ADDENDUM NO. 2

Date: January 26, 2018

Project: Phoebe Hearst Class Size Reduction Restroom

SHEET TITLE: DETAILS	
JOB NUMBER: -	SHEET NUMBER: ADD-2 CCD-1 A571
DATE: 25 JUNE, 2017	
DRAWN BY: SJT

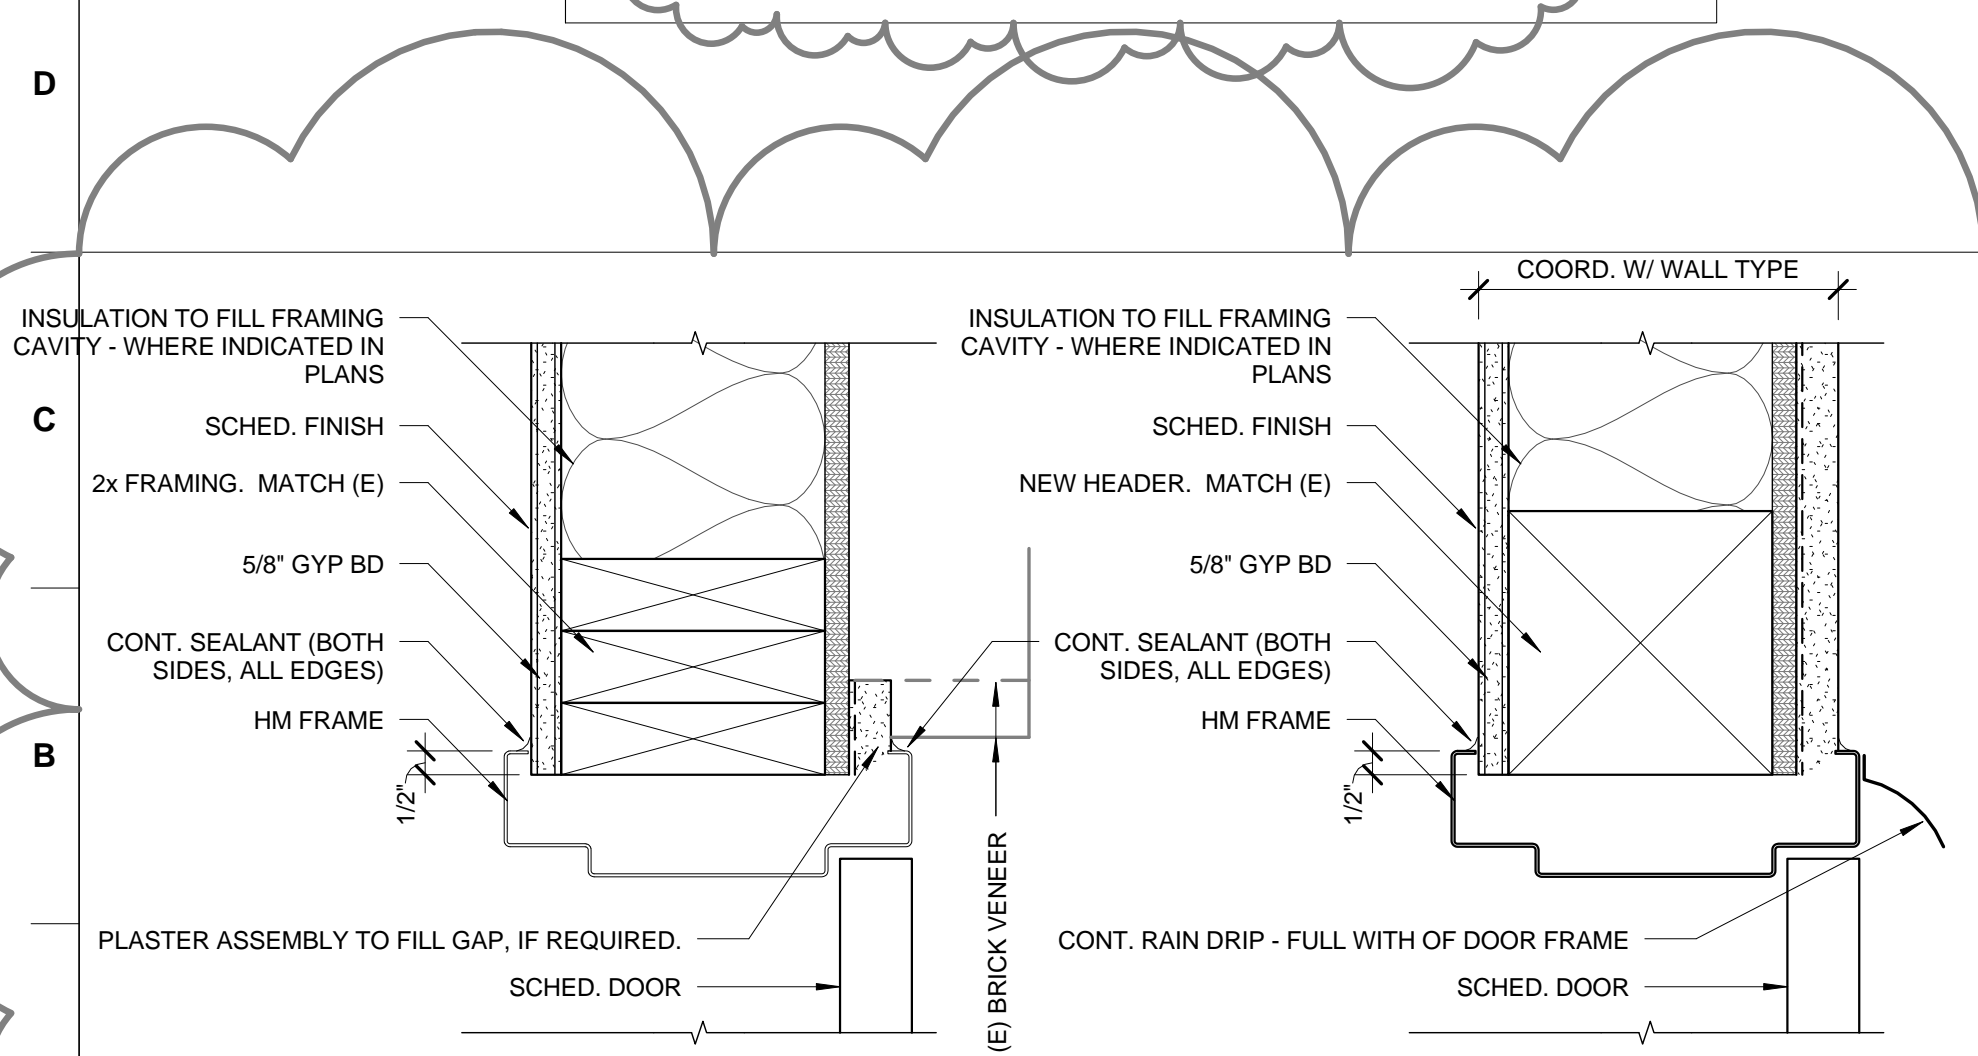
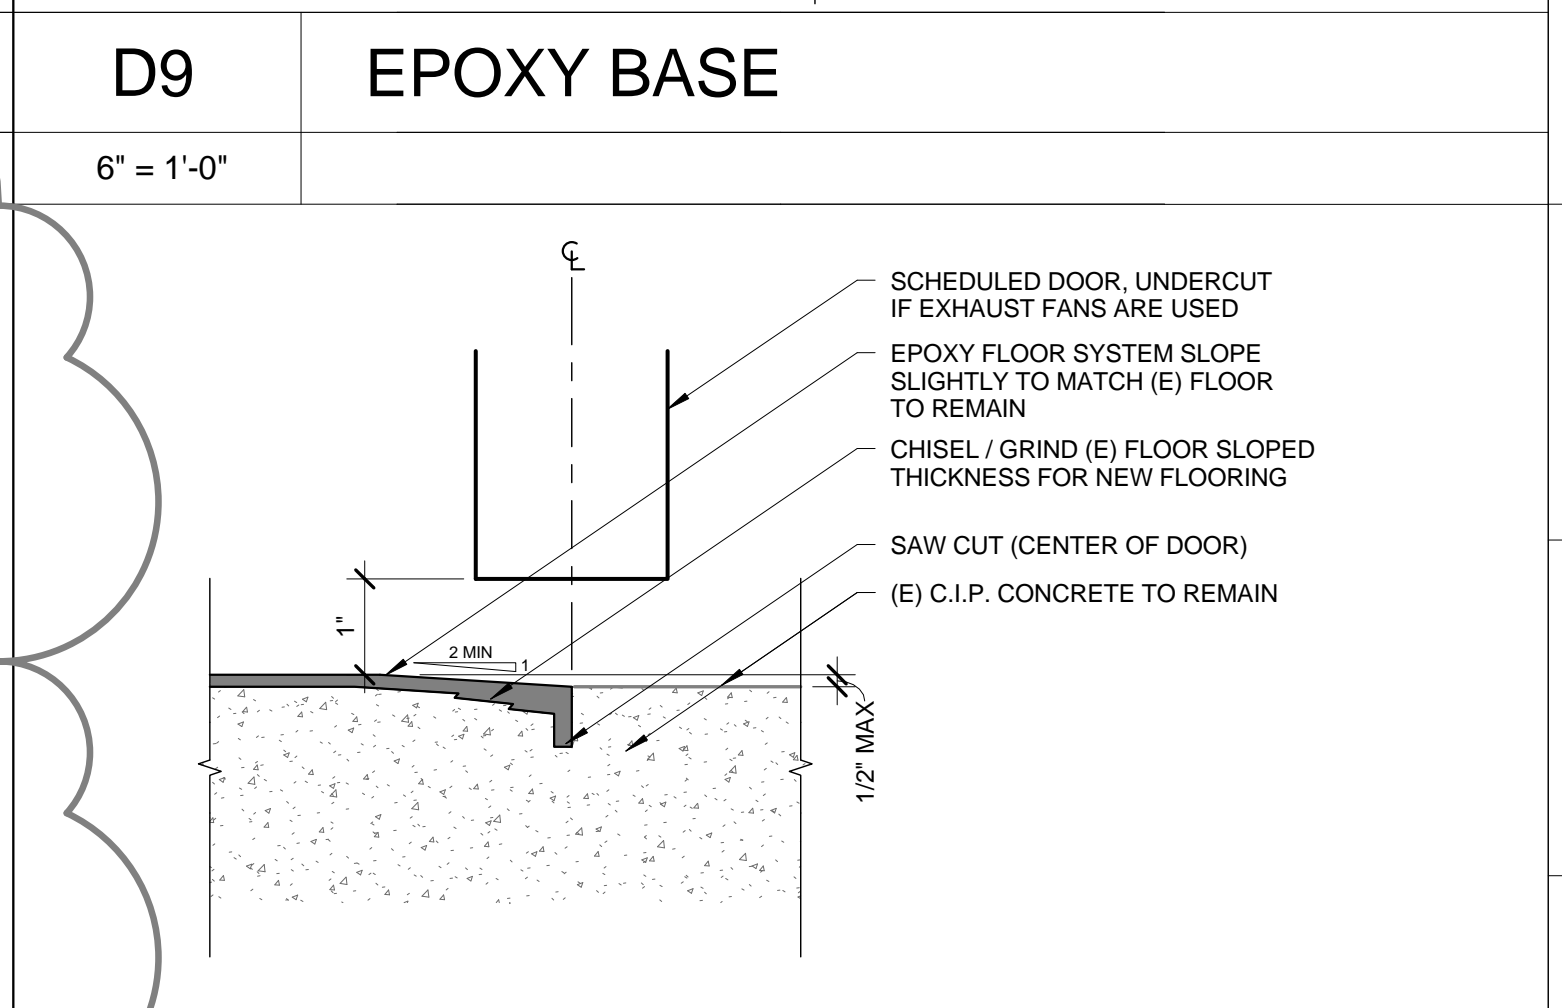
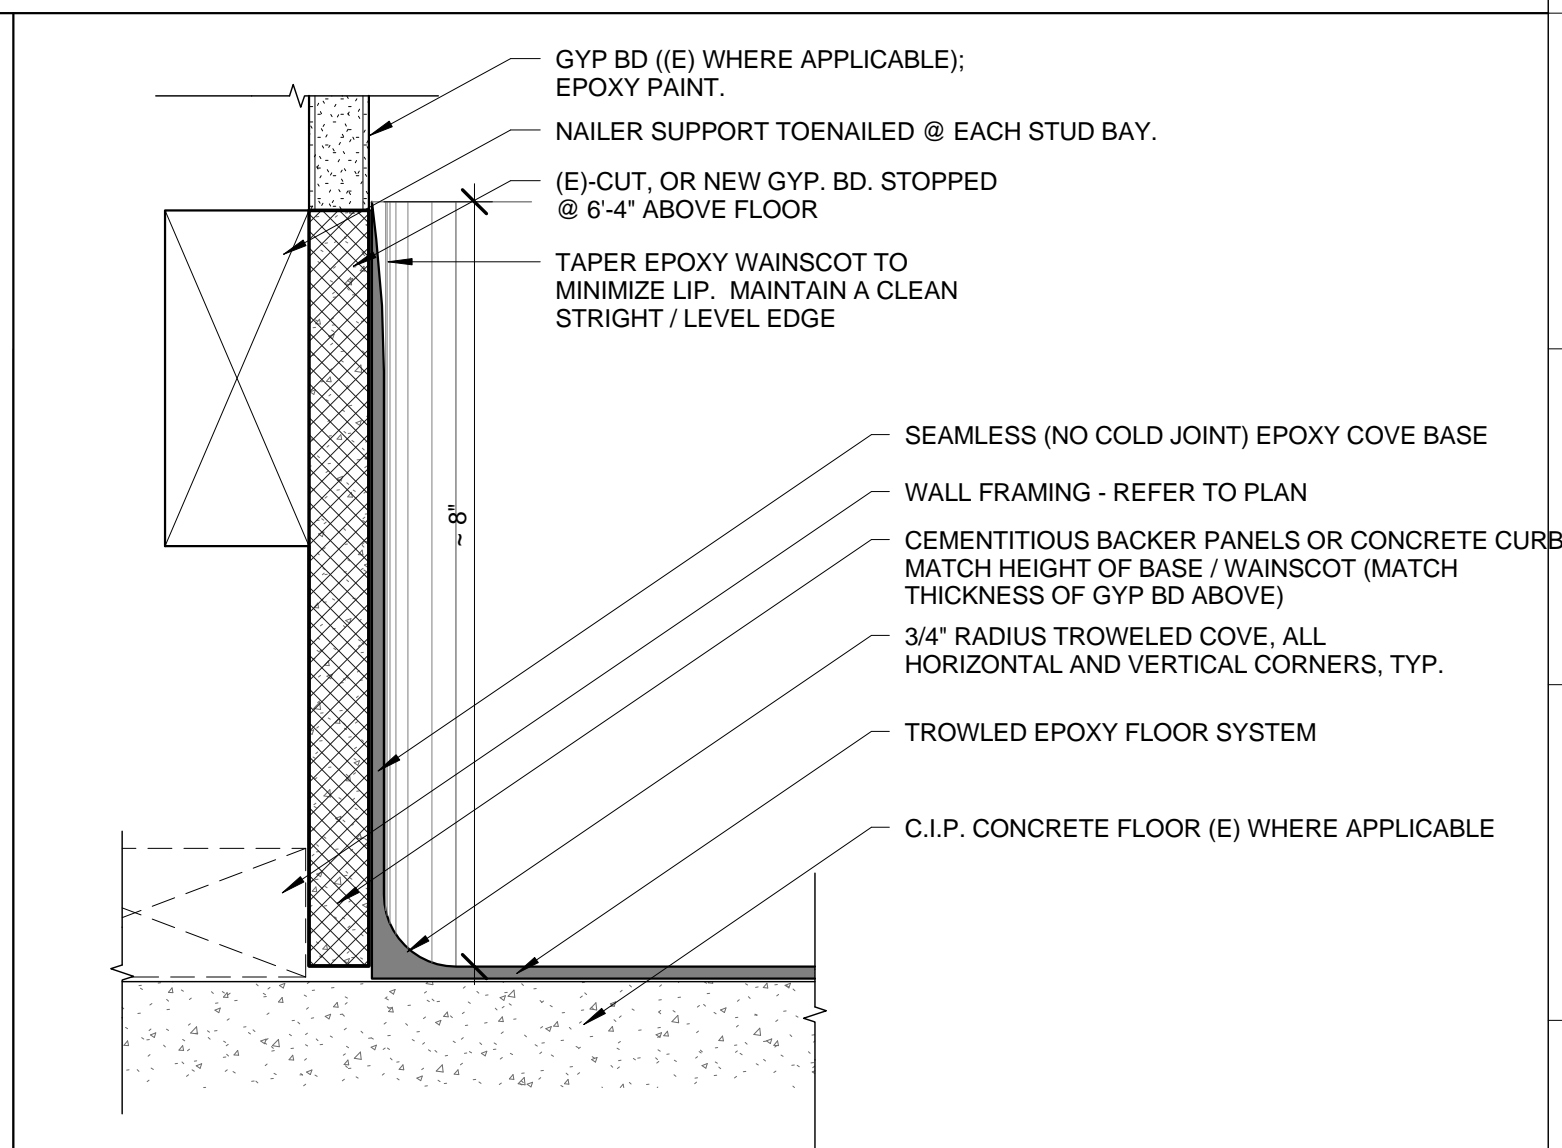
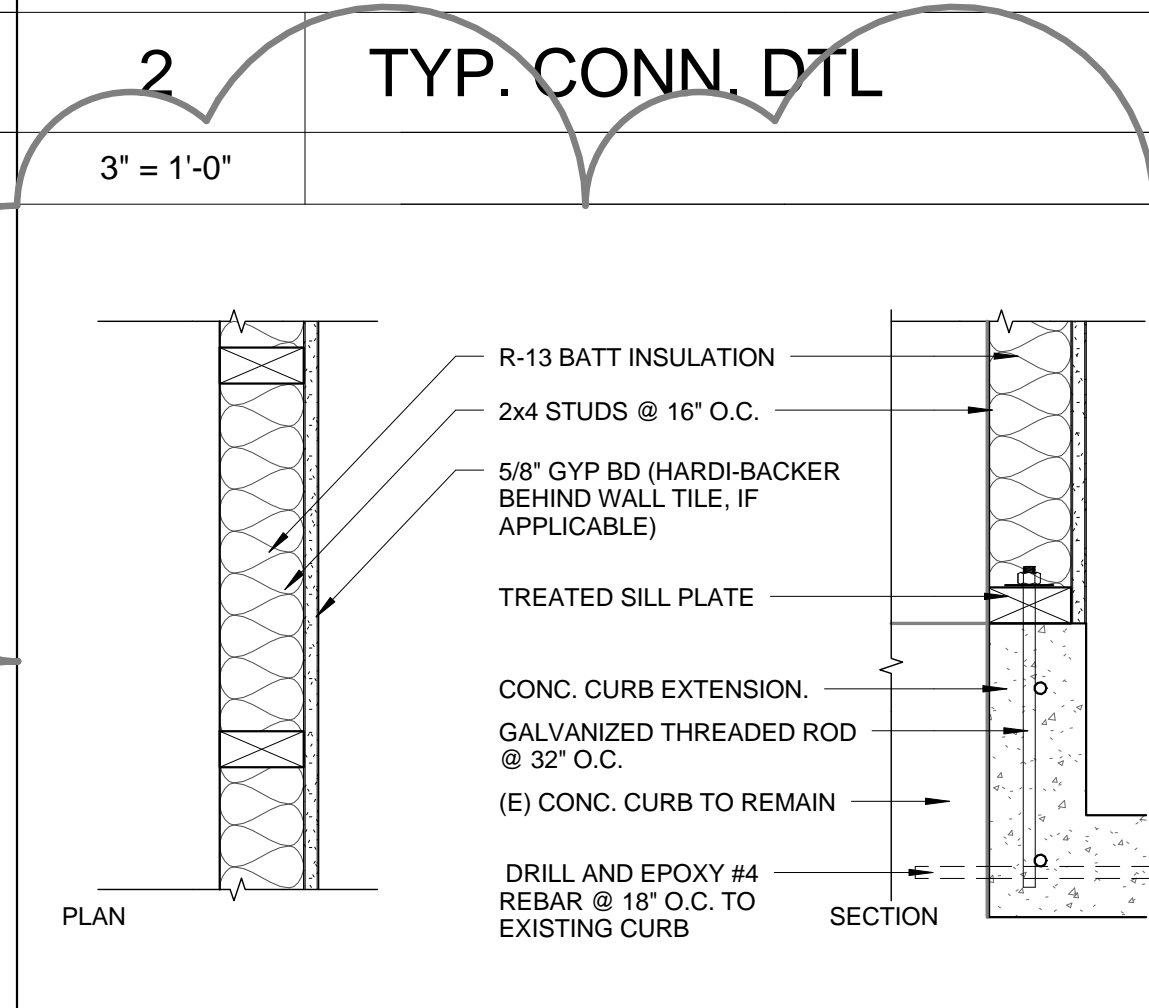
ITEM # 2.6 Sheet CCD-1 A571 – Details: Replace this sheet with the attached Sheet ADD-2 CCD-1 A571 – Details. All changes have been clouded.
